BAR Meeting
September 16, 2015

ISSUE: Permit to Demolish and Certificate of Appropriateness

LOCATION: 733 South Fairfax Street

BAR2015-00200 & BAR2015-00201

733
S. FAIRFAX
REAR ELEVATION

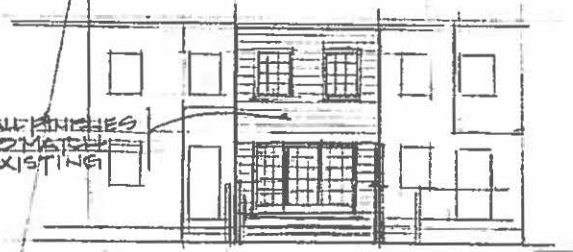
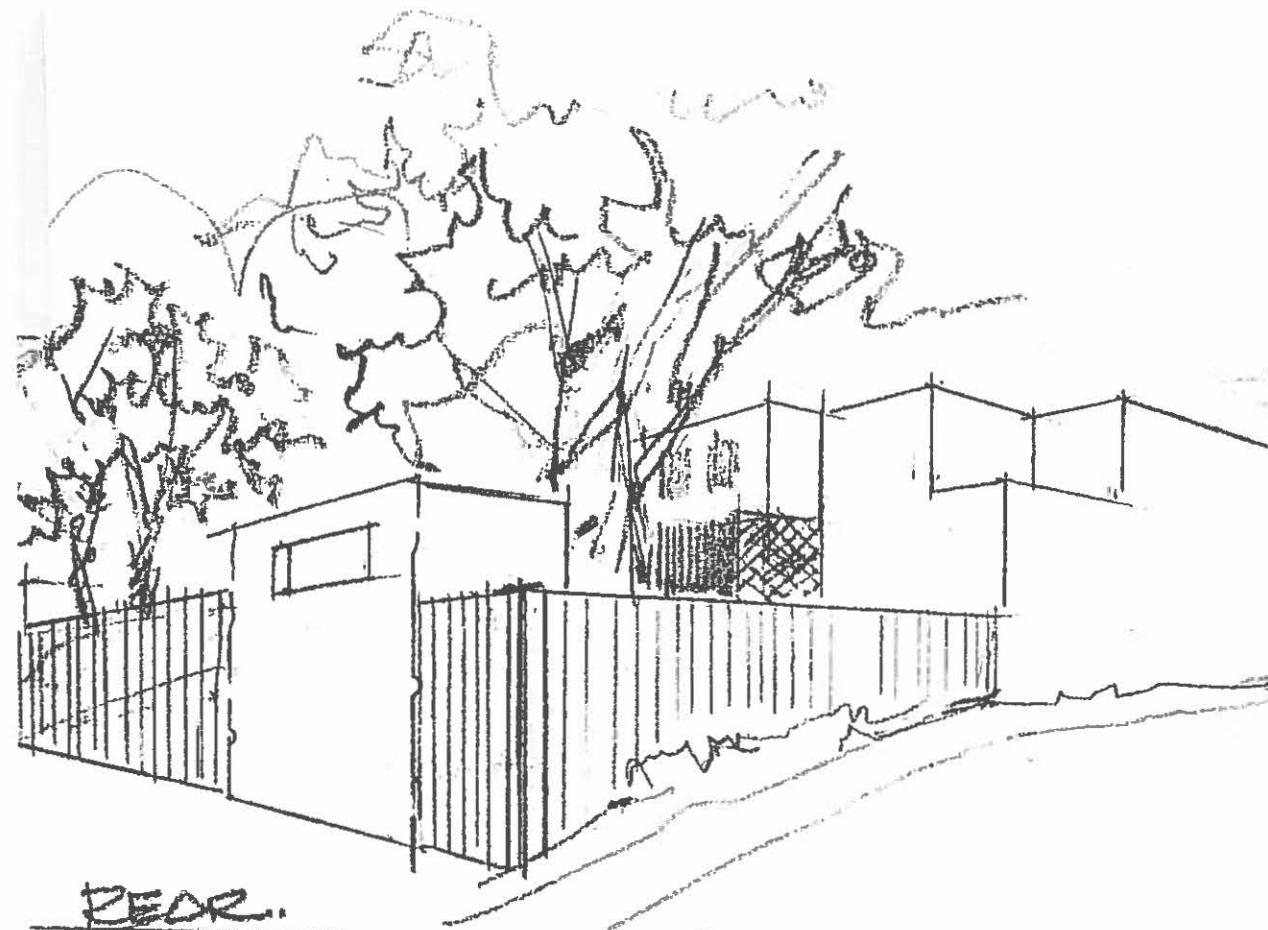
1. Eliminate the entrance door hood or a substitute design in the Colonial Revival style, to be approved by staff;
2. Work with staff during the building permit process to ensure the details of the addition, such as trim profiles are consistent with the Board's directions;

ELEVATIONS FOR PROPOSED
ADDITION
1/4" = 1 FOOT
A4

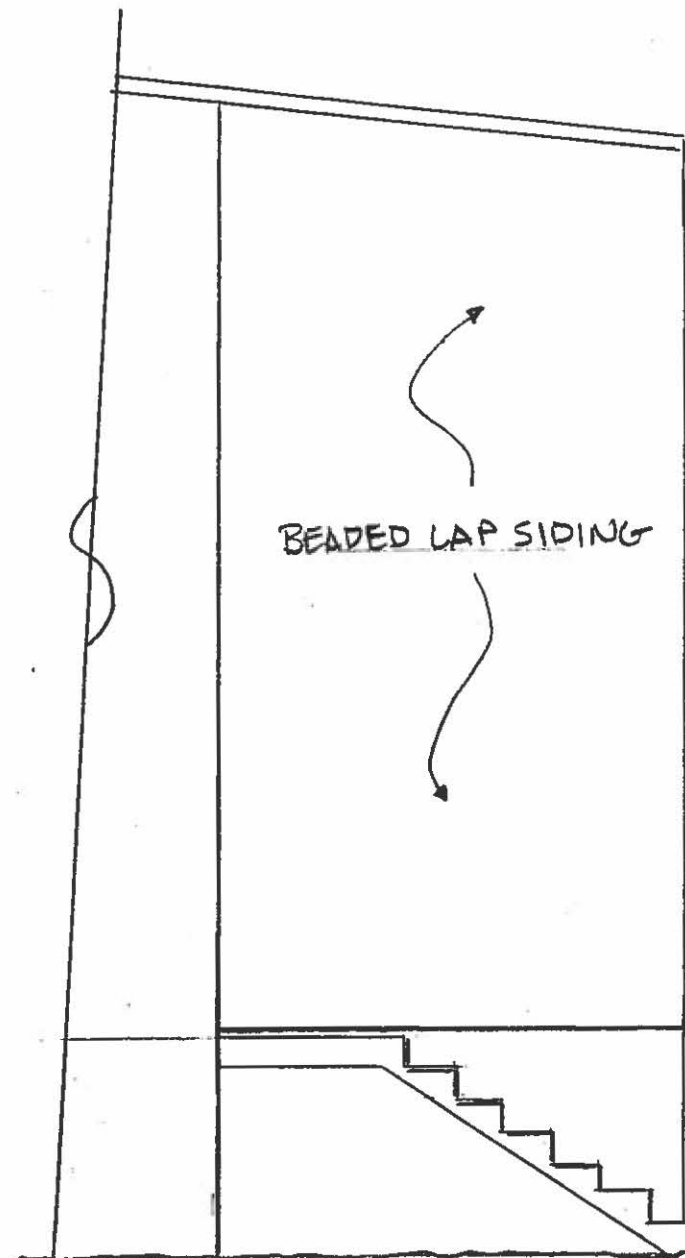
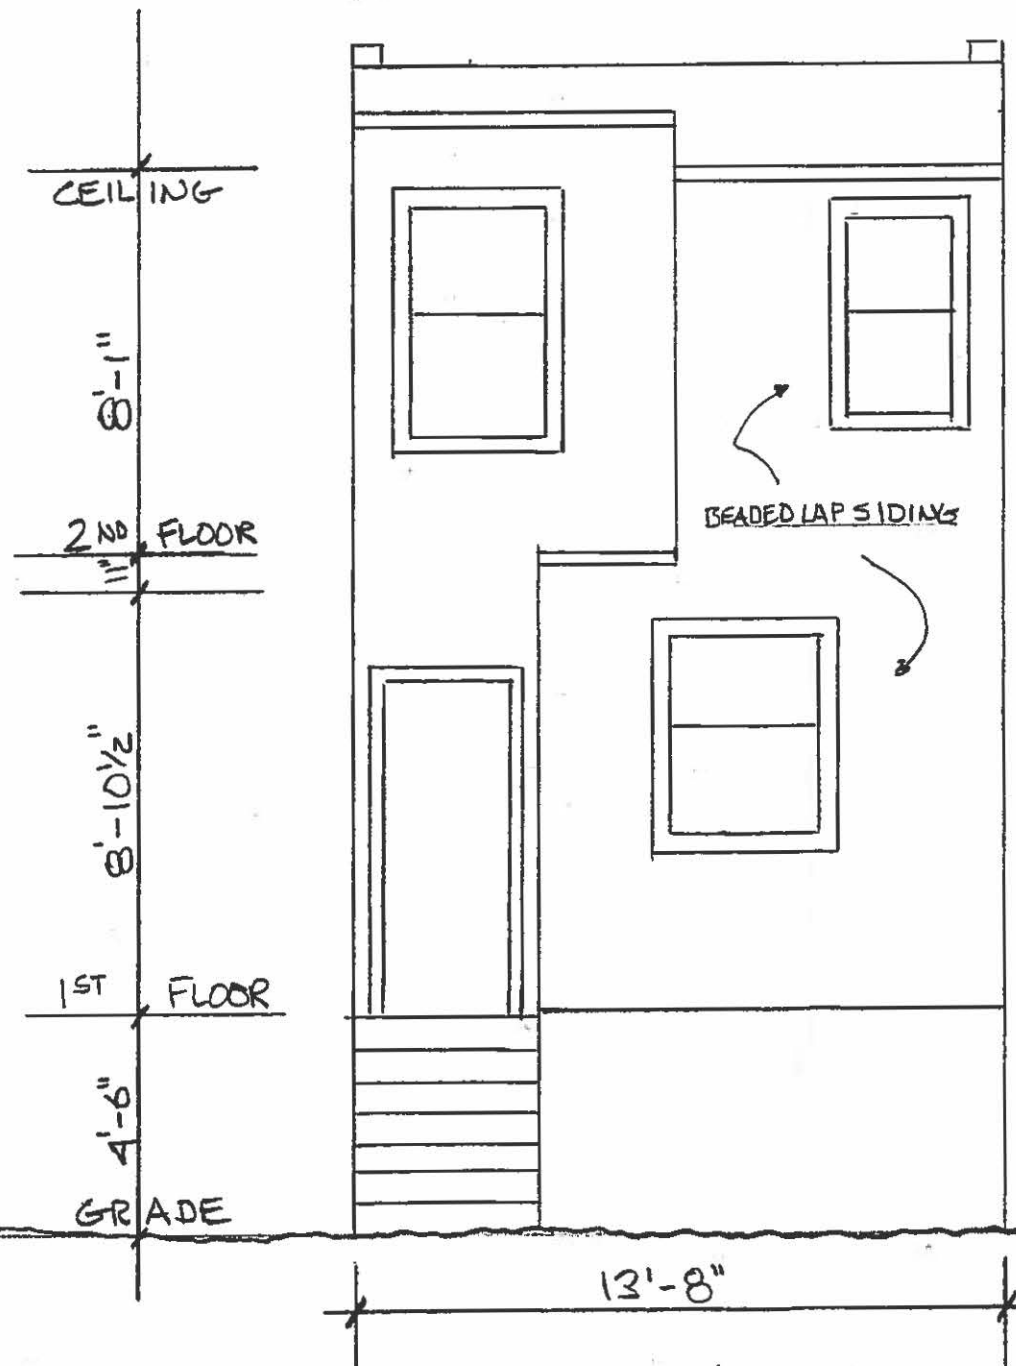
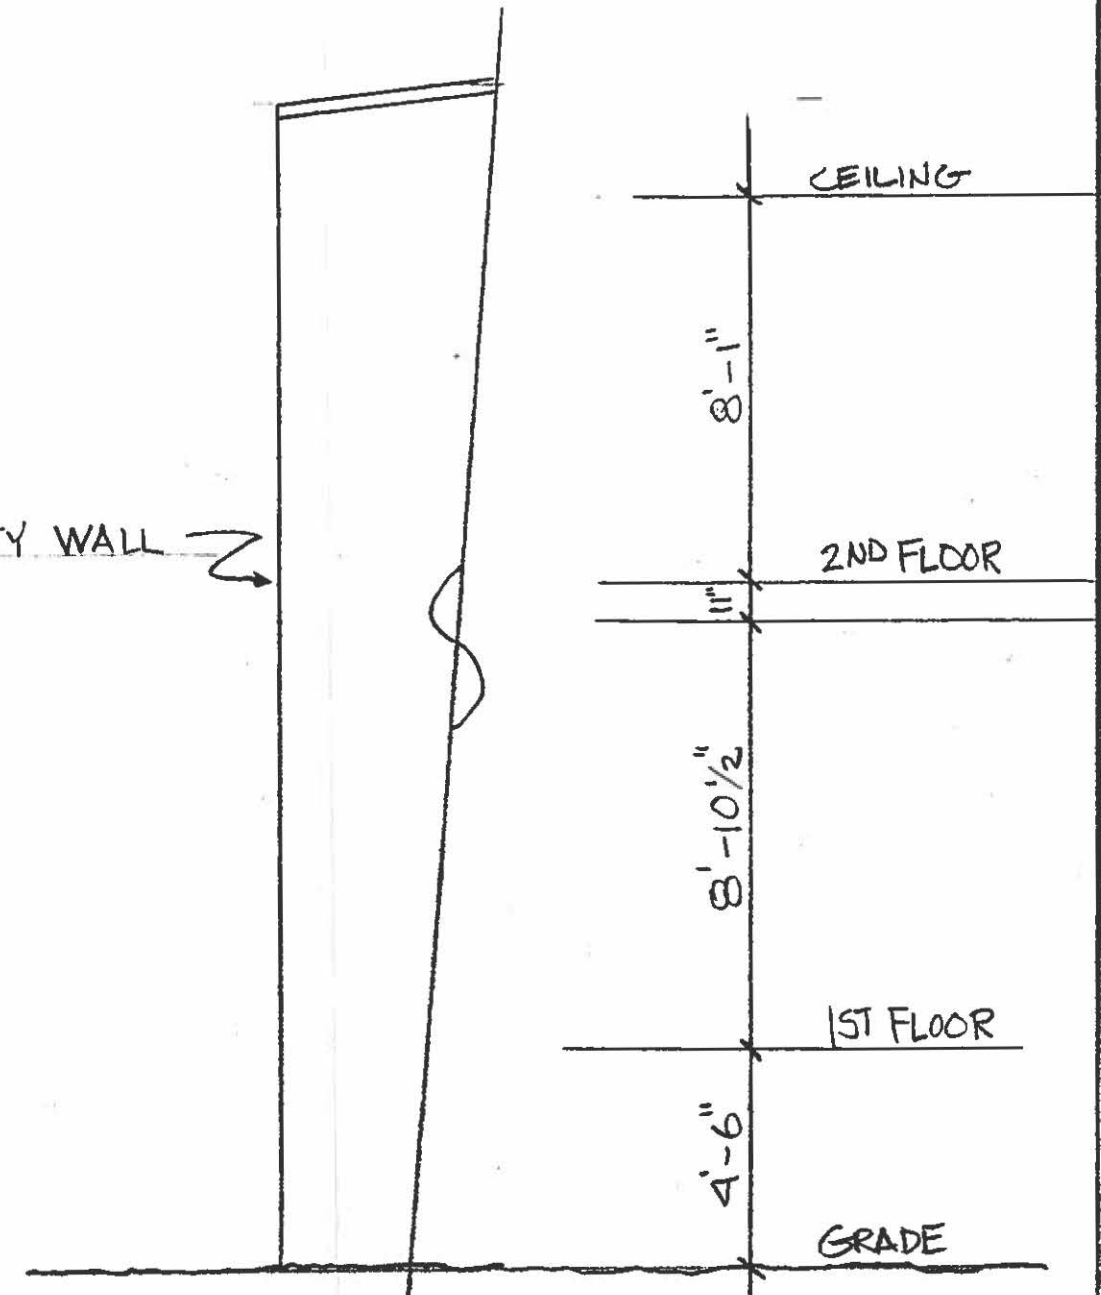
Staff's recommendation remains unchanged from the previous staff report, with the exception of the condition related to the architectural style of the proposed addition. Previously, staff had asked the Board to provide direction on the appropriate style for an addition on a house that has been significantly altered, such as this one, and with two very important periods of significance. The Board was nearly unanimous that the appropriate style for the addition should be the current style of the main block – colonial revival, as opposed to referencing the former Victorian elements of the building. For this reason, staff still recommends denial of the door hood, a common Victorian element. Front porches, entablatures, enframements, sidelights, and transoms are all Colonial Revival elements that staff finds would be more appropriate to this house.
